## **EQUIPMENT SALES SUBDIVISION**

The plat illustrates the proposed 5.7 acre  $\pm$ , 1 lot subdivision which is located on the east side of Western Drive, 180 feet  $\pm$  north of Mill Street, extending to the north side of Mill Street, 915 feet  $\pm$  east of Western Drive, and is in Council District 1. The subdivision is served by public water and sanitary sewer.

The purpose of this application is to create one lot from two existing lots. The site has a distribution center on the lot abutting Western Drive, and has a small warehouse on the 52-foot wide portion of the lot that fronts Mill Street.

# LOCATOR MAP

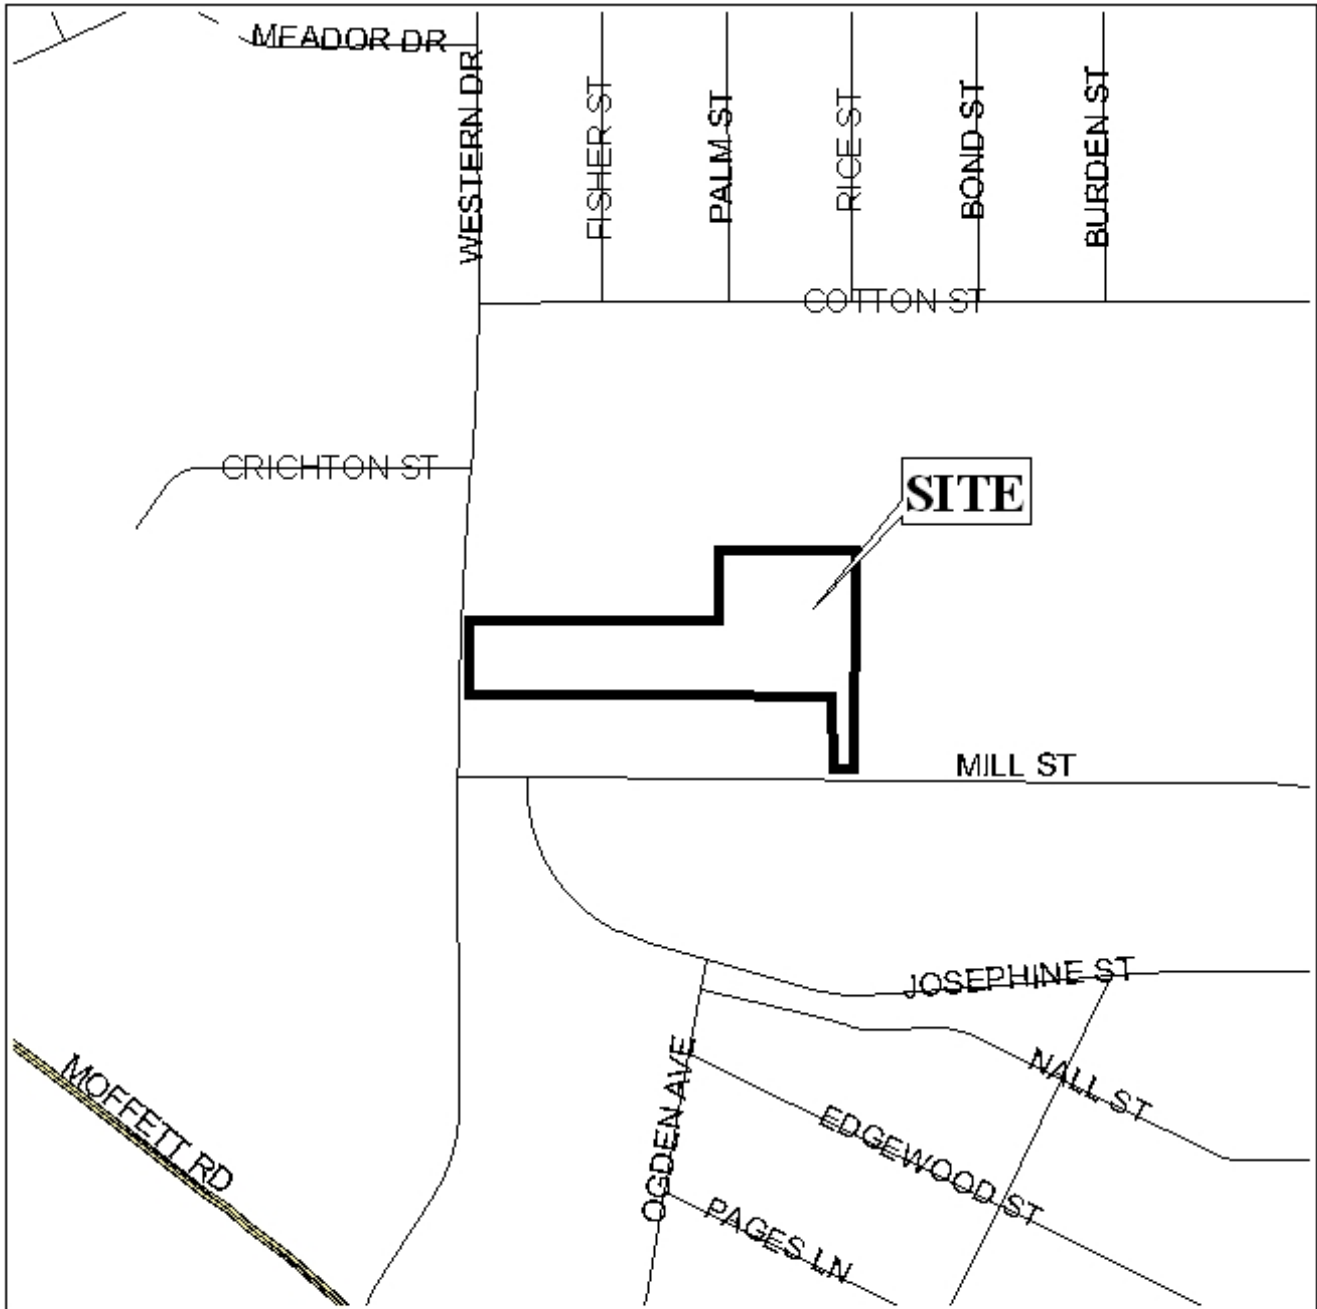
The site fronts onto two streets: Western Drive to the west and Mill Street to the south. Western Drive was at one time a component of the Major Street Plan, and because of this the preliminary plat depicts "*An area reserved for future purchase by the City of Mobile for additional right of way*" on the portion of the site that abuts Western Drive. Since Western Drive has an existing right-of-way of 50 feet and has been removed from the Major Street Plan, the reservation for additional right-of-way is no longer necessary. Thus the plat should be revised to remove the reservation, and correspondingly adjust the 25-foot minimum building setback line.

The site currently has one curb cut to Western Drive, while access to Mill Street appears to be limited due to the existing small warehouse on the 52-foot wide portion of the lot. As two separate lots, one curb cut to their respective frontage streets would have been permitted. Therefore, the resubdivision into one lot should be limited to a maximum of two curb cuts: one to Western Drive and one to Mill Street. Changes to existing curb cuts, or proposals for new or relocated curb cuts, must be reviewed and approved by Traffic Engineering.

The proposed lot's depth to width ratio is approximately 5 (depth is 5 times the width of the lot at the minimum building setback line), which is greater than the 3.5 recommended in Section

V.D.3. of the Subdivision Regulations. The proposed lot's high depth to width ratio is due to the combining of two lots, one of which is flag-shaped, and which has frontage on Mill Street. Other lots in the area do not reflect similar depth to width ratios. However, the large size of the block containing this site, and the existing development along the edges of the block, provide evidence that alternatives to the subdivision as proposed may not be possible. Thus a waiver of Section V.D.3. could be considered appropriate.

With a waiver of Section V.D.3., the plat is recommended for Tentative Approval, subject to the following conditions: 1) revision of the plat to remove the area reserved for future right-of-way, and corresponding adjustment of the 25-foot minimum building setback line; and 2) placement of a note on the Final Plat stating that the lot is limited to a maximum of two curb-cuts, one to Western Drive and one to Mill Street, with the size and location to be approved by Traffic Engineering.
